HISTORIC AND DESIGN REVIEW COMMISSION

October 21, 2020

HDRC CASE NO: 2020-388
ADDRESS: 313 N PINE ST
LEGAL DESCRIPTION: NCB 585 BLK 3 LOT 7 & 8
ZONING: RM-4, H
CITY COUNCIL DIST.: 2
DISTRICT: Dignowity Hill Historic District
APPLICANT: Felix Ziga/Ziga Architecture Studio PLLC
OWNER: Brett Henneke/Henneke Financial Group LLC
TYPE OF WORK: Construction of two, 2-story residential structures
APPLICATION RECEIVED: October 02, 2020
60-DAY REVIEW: Not applicable due to City Council Emergency Orders
CASE MANAGER: Edward Hall
REQUEST:

The applicant is requesting a Certificate of Appropriateness for approval to construct two, 2-story residential structures on the vacant lot at 313 N Pine, located within the Dignowity Hill Historic District. This lot is located at the corner of N Pine and Potomac Streets.

PROPOSED SITE/ROOF
PLAN

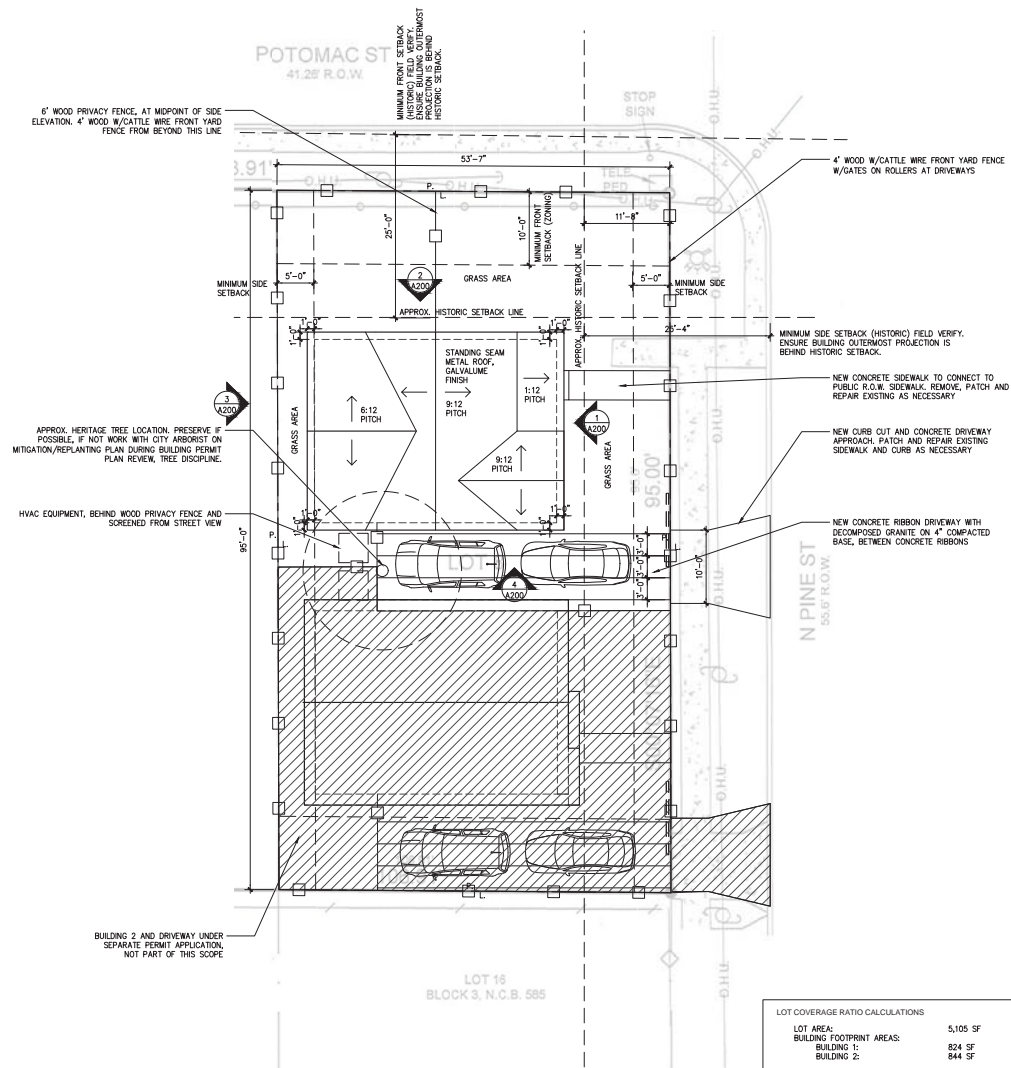
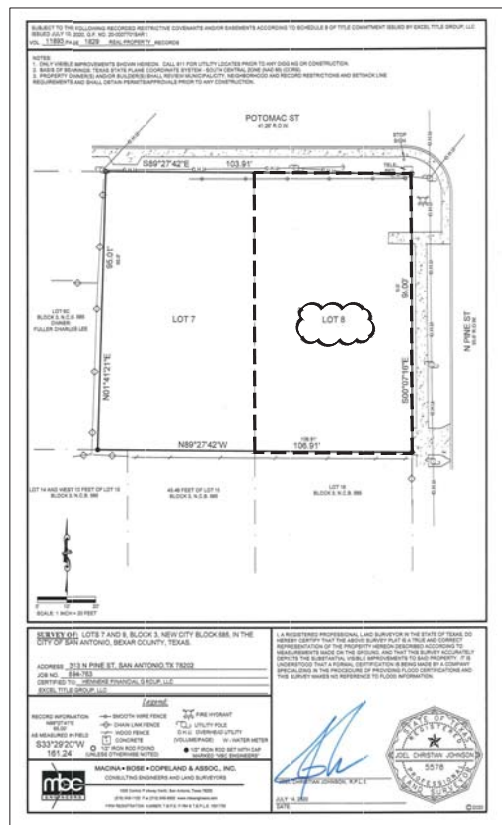
- d. **SETBACKS** – The applicant has submitted a site plan noting the proposed setbacks of both structures. The proposed new construction features setbacks that are equal to or greater than those found historically on the block. The measurement from the curb as noted on the site plan is not accurately represented as the historic house to the south is illustrated with a deeper setback than what is annotated. Staff finds that both structures should feature a setbacks that are deeper than that of the adjacent historic structure. Additionally, staff finds that the setback diagram should be revised to accurately depict the proposed setbacks.

- q. SITE ELEMENTS (Landscaping) – A stipulation of conceptual approval was the development of a landscaping plan that is consistent with the Guidelines for Site Elements. While the applicant has indicated the location of grass on the architectural site plan, a landscaping plan has not been submitted for review.

- i. That both setbacks be greater than those found on the adjacent historic structures. Additionally, staff recommends that setbacks be measured from the front (street) face of the curb to ensure a uniform measurement. Staff recommends that the proposed setback diagram be revised to note a deeper setback, as noted in finding d.

- iv. That a landscaping plan be developed to be consistent with the Guidelines for Site Elements as noted in finding q.
- v. That a lentil should be added to the bottom porch's gable end on the second structure, as noted in finding j.

A200

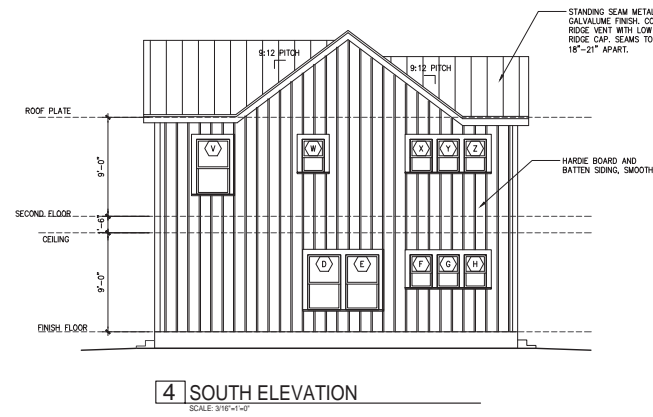
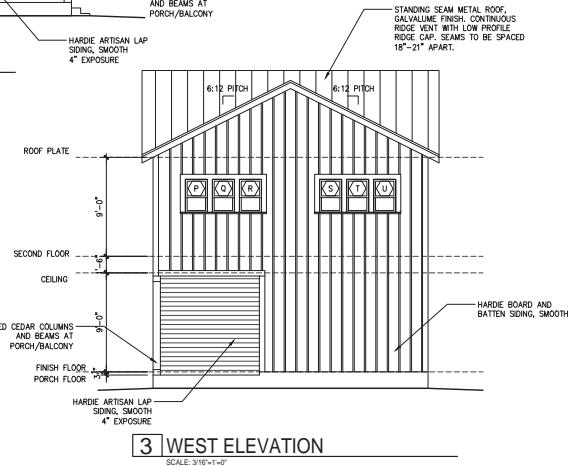
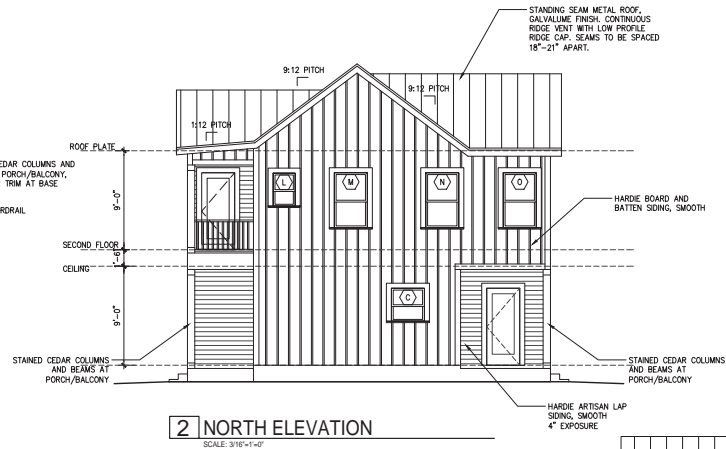
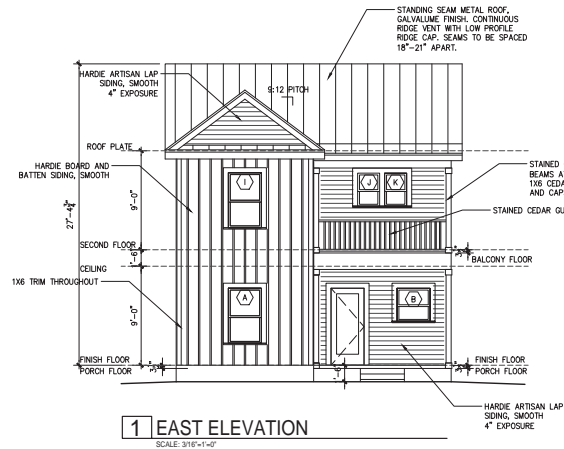
- ii. That the small, fixed windows be eliminated and full size windows, as found with correct proportions, as found historically within the district be installed. **This stipulation has not been met.**

- j. **PORCH MASSING** – The applicant has proposed porch massing that is integral to the massing of both structures. Generally, staff finds the proposed porch massing to be appropriate; however, staff finds that a lentil should be added to the bottom porch’s gable end on the second structure.

- ii. That full size windows, with correct proportions, as found historically within the district be installed as noted in finding i.
- iii. That the proposed standing seam metal roofs feature panels that are 18 to 21 inches wide, seams that are 1 to 2 inches in height, a standard galvalume finish and a crimped ridge seam or a low profile ridge cap. If a ridge cap is used, it must be reviewed and approved prior to installation. The proposed siding should feature an exposure of four inches, a smooth finish, and a thickness of $\frac{3}{4}$ ". Corner trim was conceptually approved and columns were conceptually approved to be twelve (12) inches square.
